LETTER REPORT REGARDING REMEDIAL INVESTIGATION ADDENDUM WORK PLAN
AND PRELIMINARY TREATABILITY STUDY CONCEPTUAL PLAN SITE 4 NCBC GULFPORT
MS
3/14/2006
TETRA TECH NUS

Subject: Remedial Investigation Addendum Work Plan and Preliminary Treatability Study
Conceptual Plan for Site 4
Naval Construction Battalion Center (NCBC) Gulfport
Gulfport, Mississippi

Subject: Response to comments regarding the "Remedial Investigation Addendum Work Plan and Treatability Study Conceptual Plan for Site 4"
Naval Construction Battalion Center (NCBC) Gulfport
Gulfport, Mississippi

CONTRACT NO.	0
APPROVED BY	DATE
APPROVED BY	DATE
DRAWING NO.	FIGURE 2
REV.	0

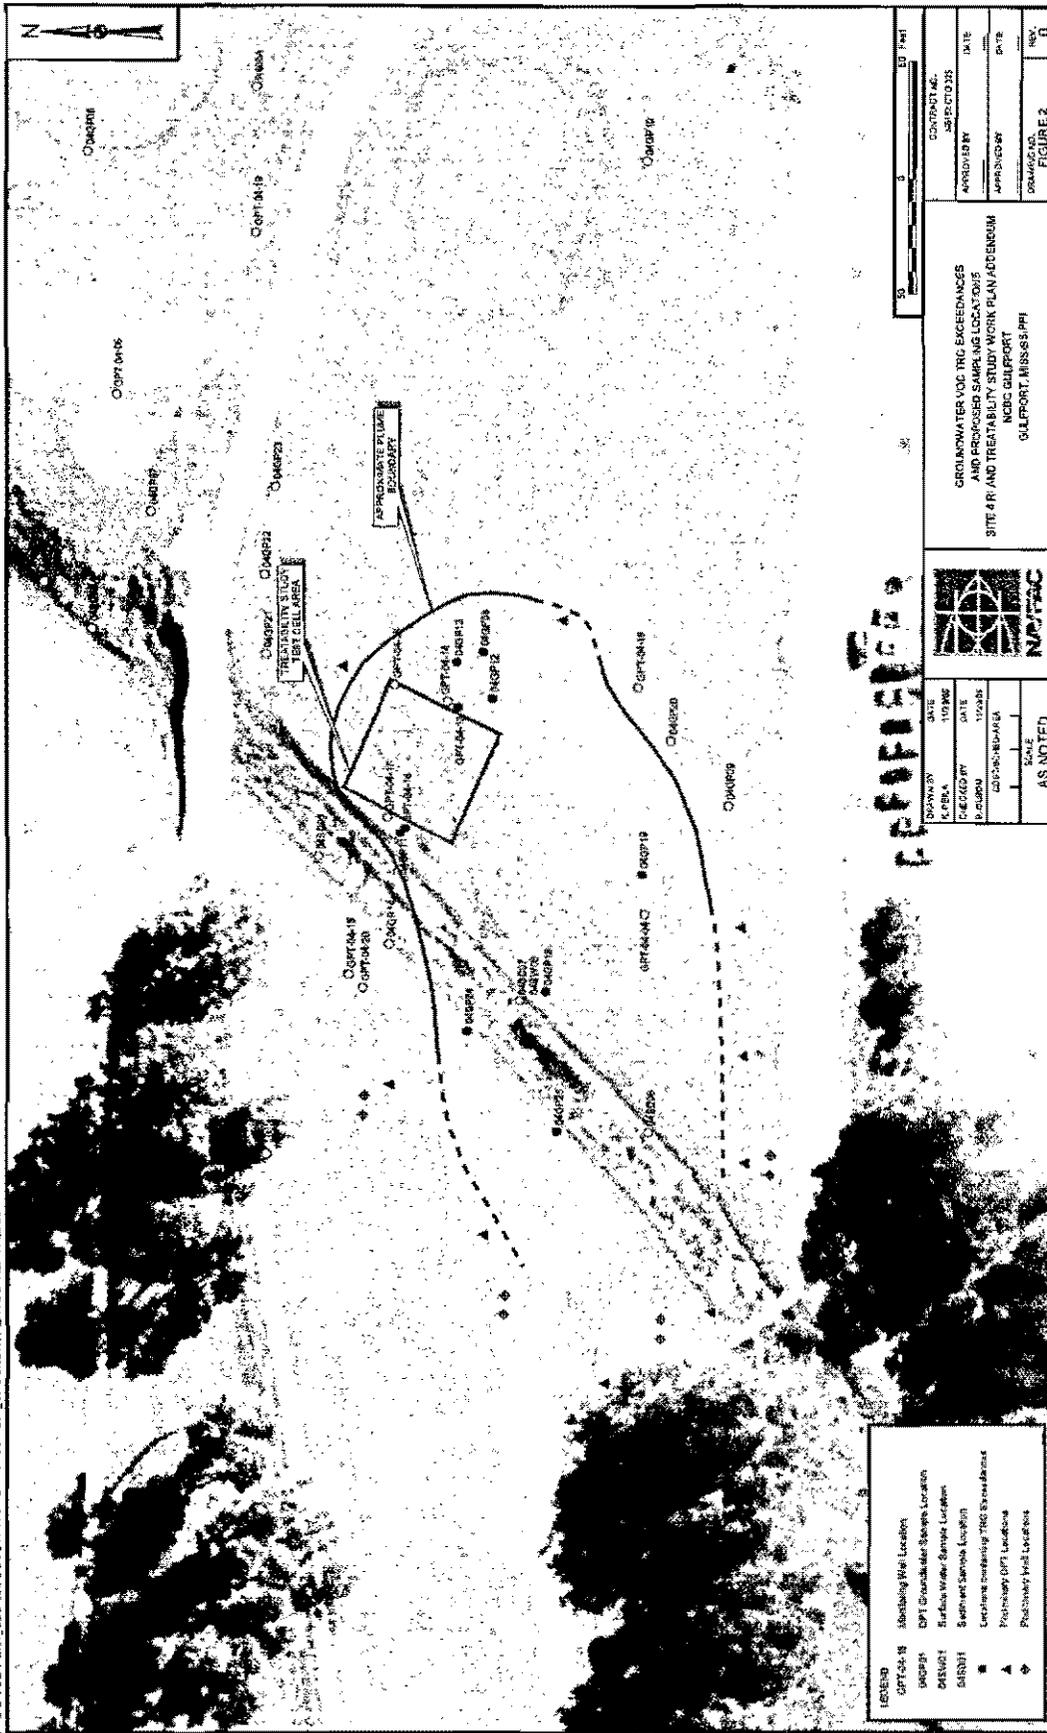
Comment #1 We disagree that comparative analysis at an offsite laboratory is needed because the DPT groundwater data provided by the mobile laboratory will be used as screening data to optimize the locations of additional permanent monitoring wells. Final decisions for the site assessment and remedial options will then be made using the higher quality analytical data from groundwater samples collected from the permanent monitoring wells.

Initially, 10 DPT borings will be advanced at locations shown on Figure 2 of the workplan to delineate the horizontal and vertical extent of the CVOC plume in groundwater. If required to fully delineate the plume, up to 10 additional soil borings will be advanced. Soil samples at each soil boring location will be screened in the field using standard headspace methods. Groundwater sample intervals for on site analysis will be based on the field observation of lithology changes and field screening for organic vapors. At least two groundwater samples will be collected at each boring location, one groundwater sample near the water table and one groundwater sample at the total depth of the boring selected by the site geologist. The work plan text will be modified to clarify these quantities.
